## HISTORIC AND DESIGN REVIEW COMMISSION

### Agenda Item No: 33

**HDRC CASE NO:** 2016-254  
**ADDRESS:** 327 W CRAIG PLACE  
**LEGAL DESCRIPTION:** NCB 1858 BLK 1 LOT 16, E 10 FT OF 15 & W 10 FT OF 17  
**ZONING:** O2 H  
**CITY COUNCIL DIST.:** 1  
**DISTRICT:** Monte Vista Historic District  
**APPLICANT:** William Triplett/H.E.B.  
**OWNER:** Respite Care of San Antonio  
**TYPE OF WORK:** Addition, exterior modifications  
**REQUEST:**

Existing & Proposed Front (South) Elevation - HEB Respite Care Carriage House

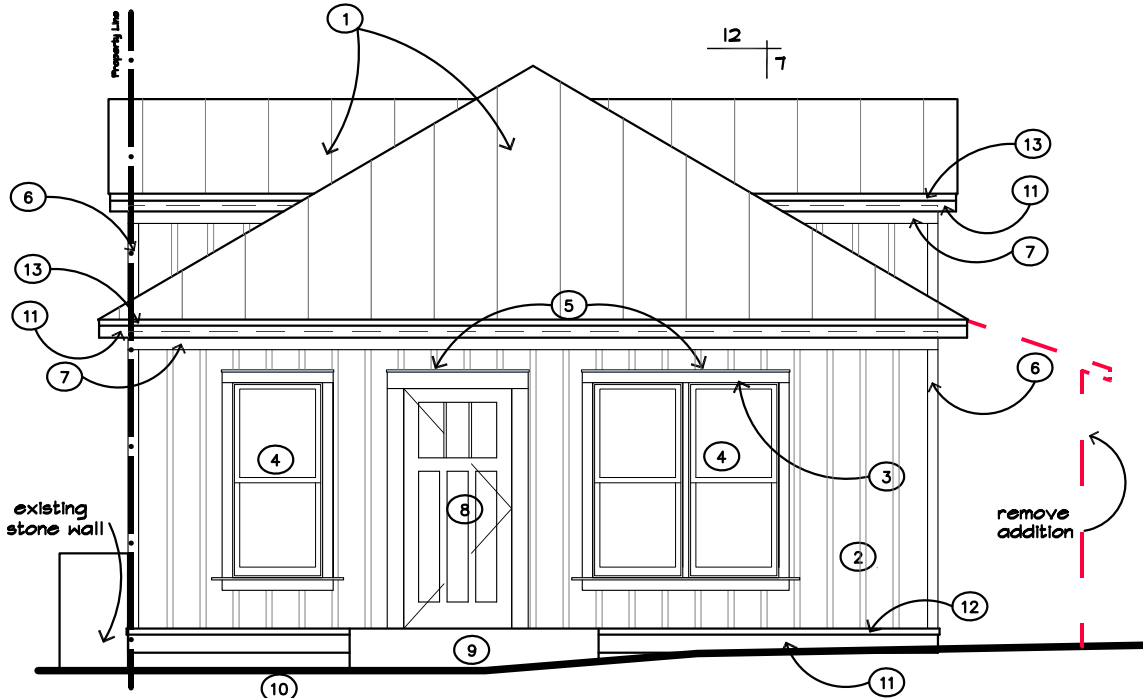
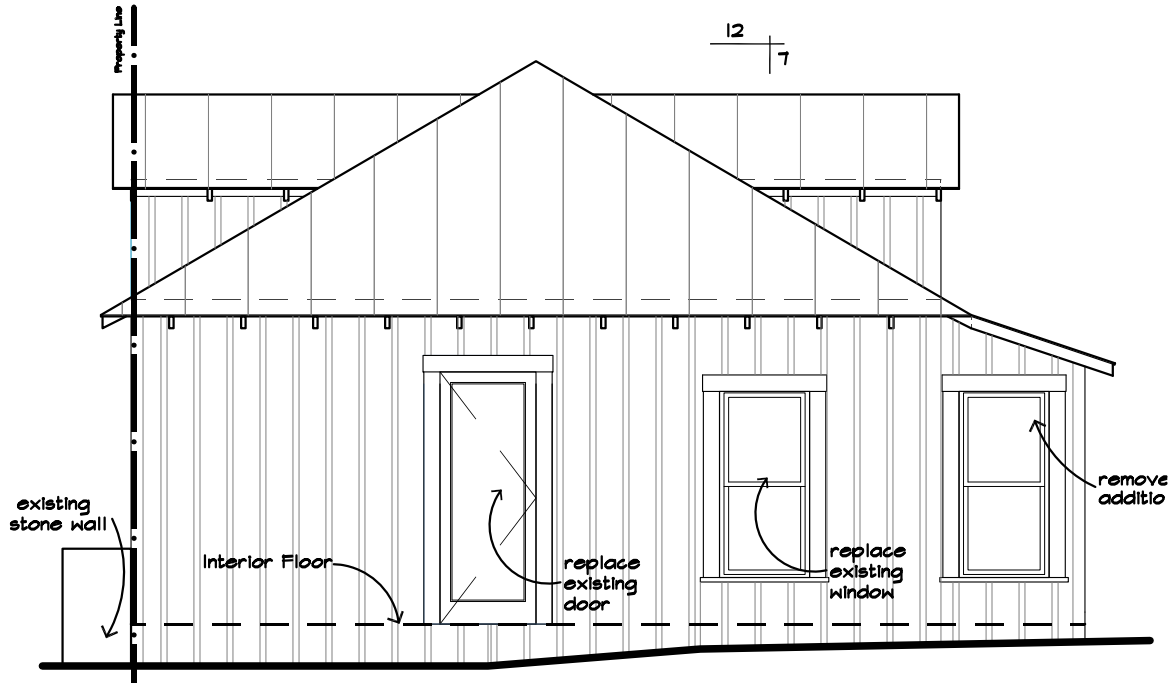
- d. The applicant is also proposing to create and alter four openings, one on the south elevation, and infill all three windows on the west elevation. According to the Guidelines for Exterior Maintenance and Alterations 6.B.i, window and door openings should be preserved. The proposal to alter window openings is not consistent with the Guidelines. Staff recommends that the existing window openings be preserved.

- h. The applicant is proposing to replace existing non-historic door on south façade with another door. The applicant is proposing to replicate the front door of the main structure and install it on the Carriage House. According to the Guidelines for Exterior Maintenance and Alterations 6.A., historic doors should be repaired, or replaced when necessary with a style of door that is historically appropriate. Staff finds the proposed door consistent with the Guidelines.

Staff recommends denial of items #1, 2, 8 and #9 based on findings a through e and finding j. Staff recommends that the applicant repair those windows that are repairable and replace when necessary with wood windows of the same dimension and profile, feature clear glass, and recessed within the window frame. Staff recommends the applicant repair the existing siding, where repair is not possible replace with in-kind materials with the same dimensions.

Existing & Proposed Right (East) Elevation - HEB Respite Care Carriage House

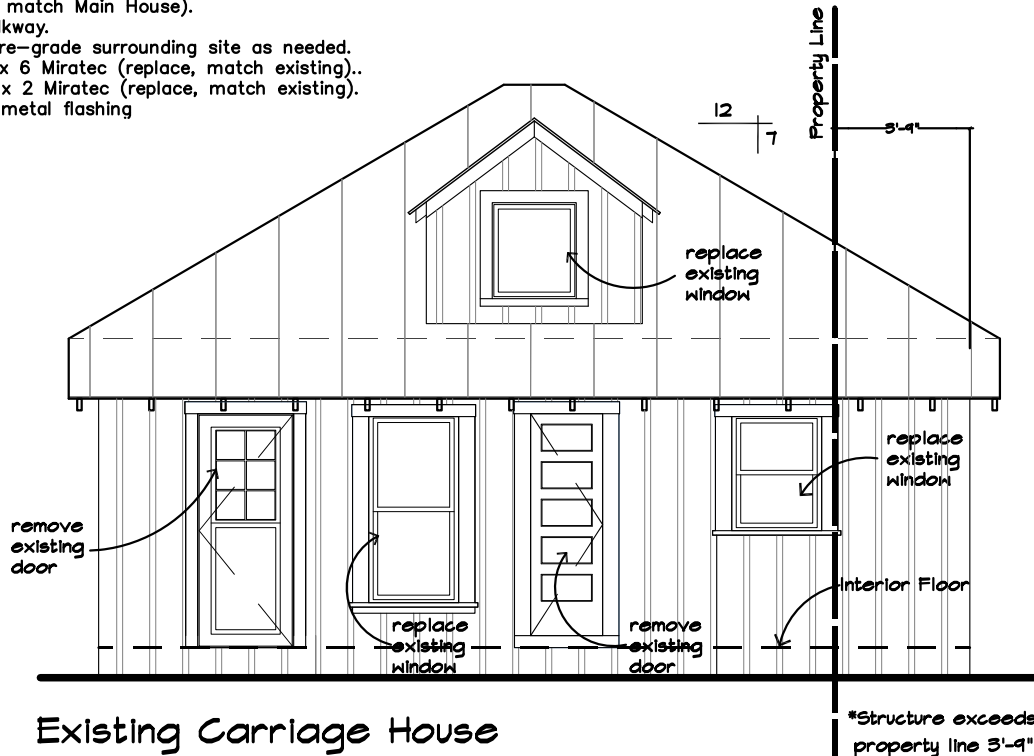
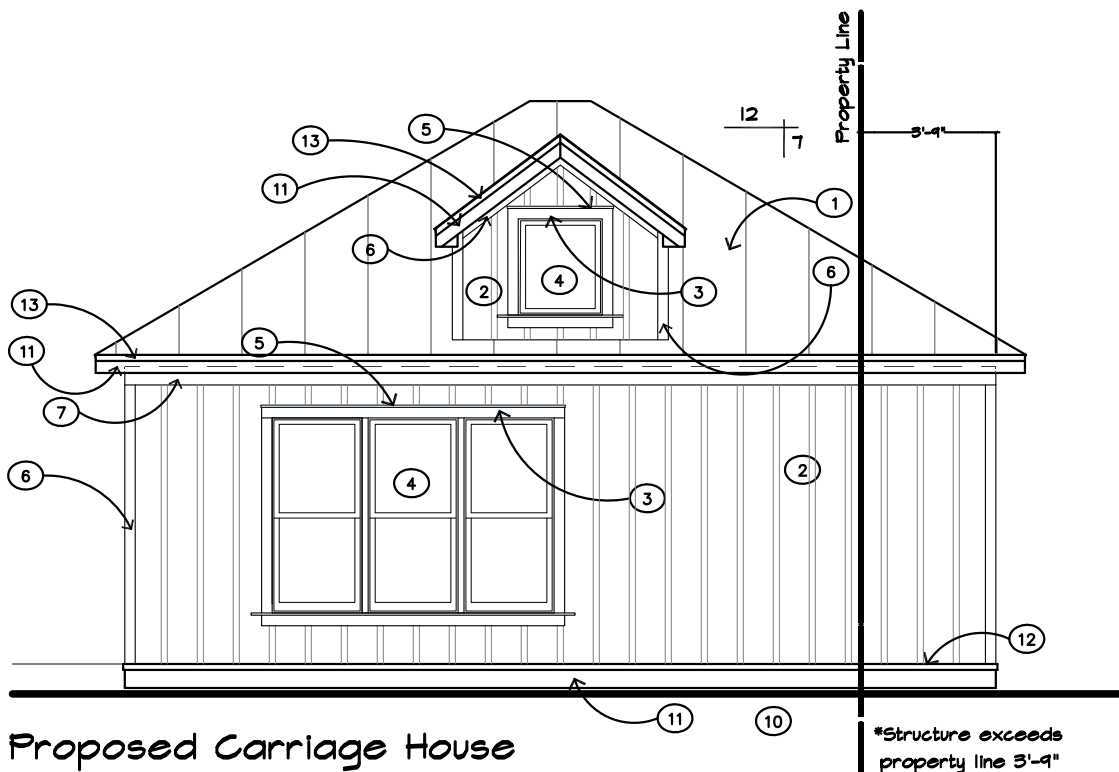
- f. The applicant is proposing to install a triple wood window, consisting of three one over one windows on the new east elevation where the addition was removed. The applicant is also proposing to install one wood one over one window in the south elevation. The new windows match the proportions of the existing one over one windows.

- g. Staff finds the new windows consistent with the Guidelines for Exterior Maintenance and Alterations 6.B.iv., which states to install new windows to match the historic or existing windows in terms of size, type, configuration, form and detail. However, staff recommends that the applicant attempt to salvage the wood windows from the addition that is proposed to be demolished.

- i. The applicant is proposing to demolish the existing rectangular addition on the east side of the carriage house. The structure appears on the August 1935 Sanborn map without the shed addition. Staff finds the removal of the non-historic addition appropriate.

Staff recommends approval of items #3 through #7 based on findings f through i with the following stipulations:

1. That the applicant used salvaged windows from the addition when creating new window openings.
